Service Bulletin

Revised version: Announcement of DX-D 100 Version 5.0

DD+DIS076.14E

Figure 3

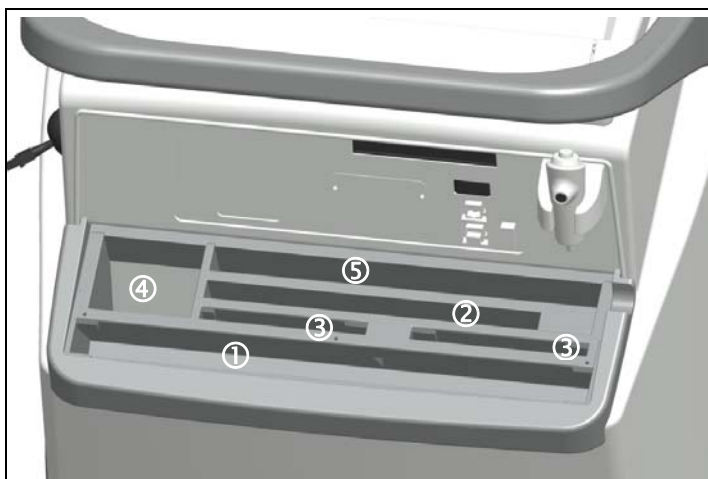
Symptom The back cover on the DX-D100 Wireless got broken several times.

Cause Due to the design, the back cover of the storage bin was easily damaged.

- **DX-D 100 Wireless only** - Reinforced storage bin that is able to include:
 - DX-D 30C Wireless detector, 46 x 38.4 x 1.5 cm ①
 - DX-D 30 handle frame ①

- DX-D 35C Wireless detector, 30.7 x 38.4 x 1.5 cm ②
This part is removable so in case of a unit where no DX-D 35C will be used this part can be taken out to have more storage space,

- Two detector batteries, 12.7 x 16.1 x 0.7 cm ③
 - Box for roll of protective bags for the detector ④
 - A facility (belongs to ①) that makes it possible to put a protective plastic bag over the detector and then pull it out of the holder.
Benefit: the operator has both hands free to put the bag over the detector that is placed in the “bagging” slot.

- Patient documents ⑤
- DX-D 100 and DX-D 100 Wireless optional components
 - Storage bin for hand sanitizer ⑥, to be placed at the vertical column
 - Storage bin for Sani wipes ⑦, to be placed at the vertical column

- Storage bin for gloves, to be placed at the vertical column

Solution A new reinforced storage bin for the detectors has been developed.
The improved design of the storage bin prevents damage to the back cover of the detector holder.

Figure 5

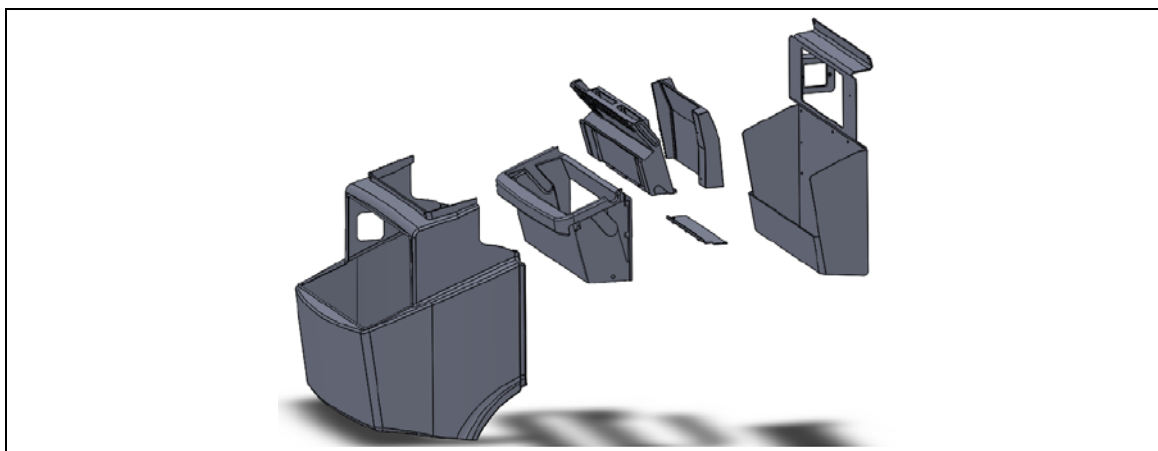
- DETECTOR BOX DX-D100 D30-D35, SC+A520342-01
 - Reinforced storage bin
 - Back cover
 - Inner parts detector box

Figure 7

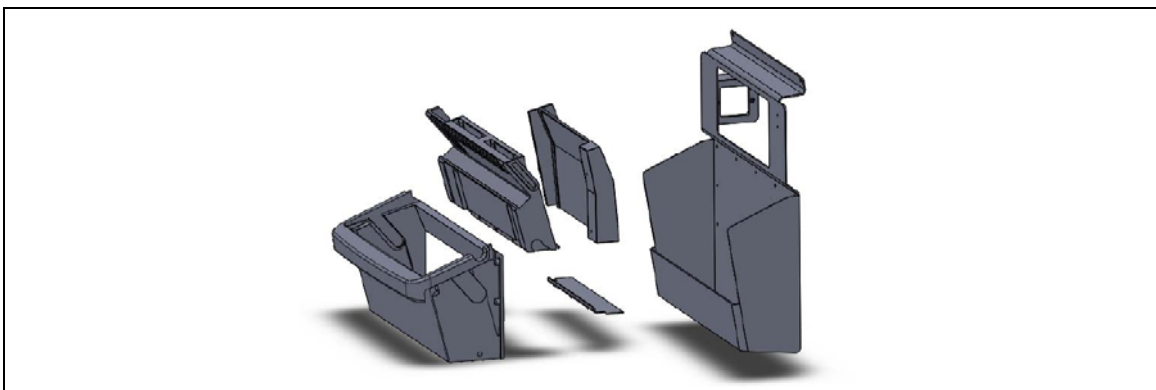
- STORAGE BIN DX D100 UPGRADE KIT, SC+A12229-01
